UNITED STATES PATENT AND TRADEMARK OFFICE

APPLICATION NO.	FILING DATE	FIRST NAMED INVENTOR	ATTORNEY DOCKET NO.	CONFIRMATION NO.
10/629,882	07/28/2003	John C. Devine	MER103	5575
20482 7590 02/08/2007 GARRISON ASSOCIATES 2001 SIXTH AVENUE SUITE 3300 SEATTLE, WA 981212522			EXAMINER NGUYEN, HANH N	
			ART UNIT	PAPER NUMBER
			2834	
SHORTENED STATUTORY PERIOD OF RESPONSE		MAIL DATE	DELIVERY MODE	
3 MONTHS		02/08/2007	PAPER

Office Action Summary	Application No.	Applicant(s)	
	10/629,882	DEVINE, JOHN C.	
	Examiner	Art Unit	
	Nguyen N. Hanh	2834

DETAILED ACTION

FIG. 4

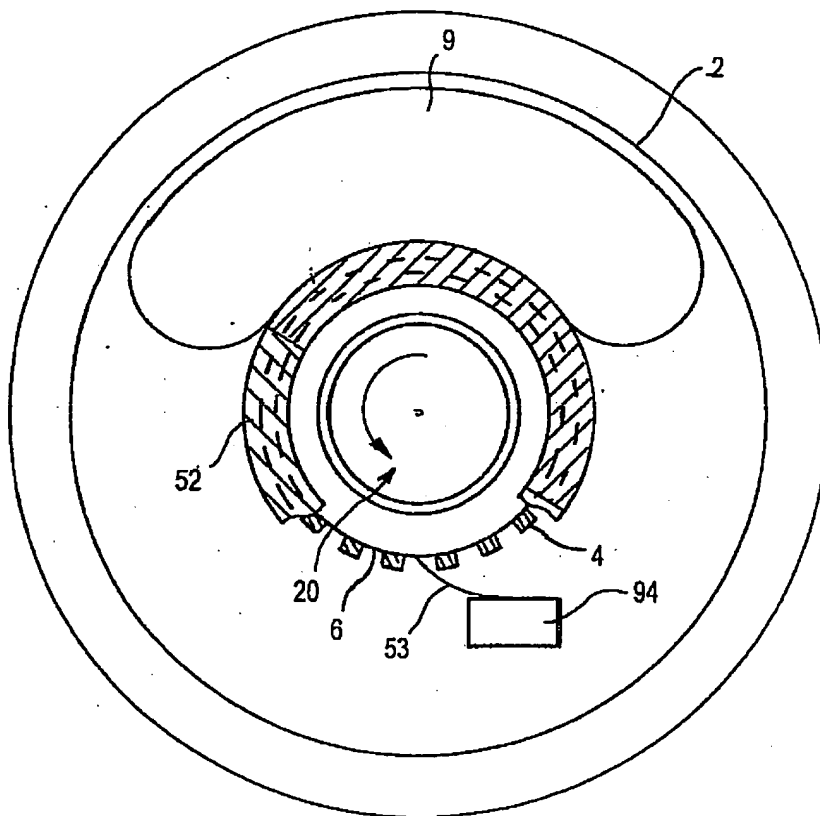
Not approved by
Examiner.
